Figure 15: Location and dimensions of lightening holes

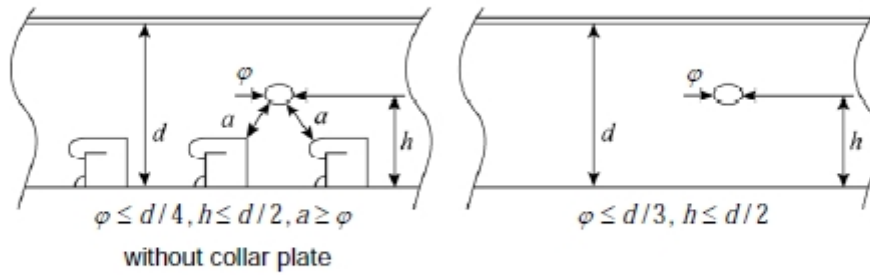
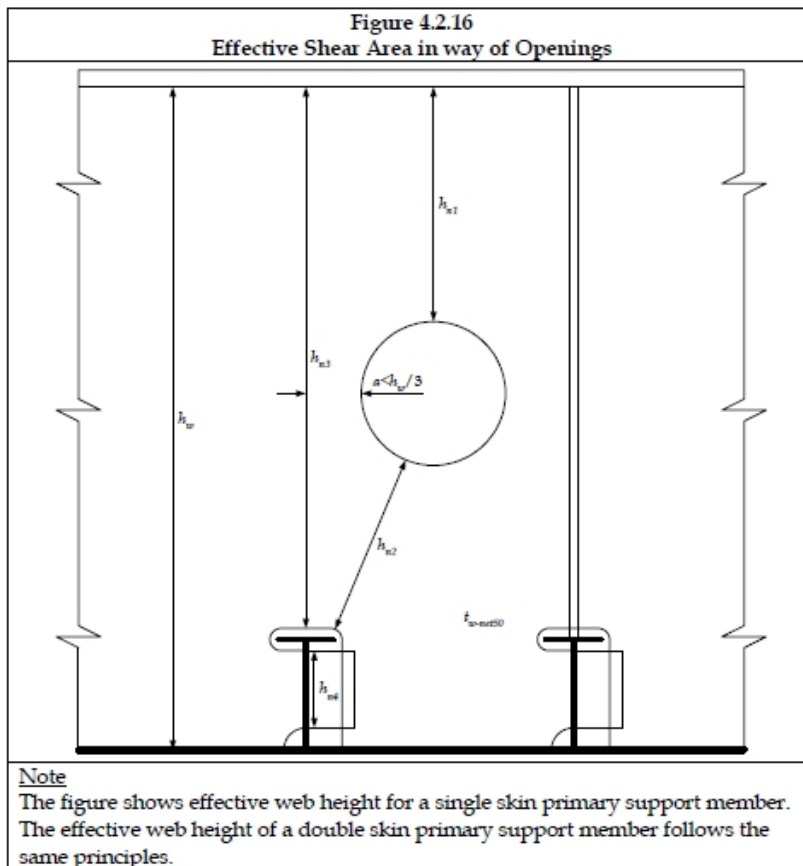
CSR-BC required the distance between opening edge and slot ' $a \geq \phi$ '.

Where lightening holes are cut in the brackets, the distance from the circumference of the hole to the free flange of brackets is not to be less than the diameter of the lightening hole.

While there is no such requirement for tanker.

I wonder would you like to limit the distance between opening edge and slot for CSR tankers?
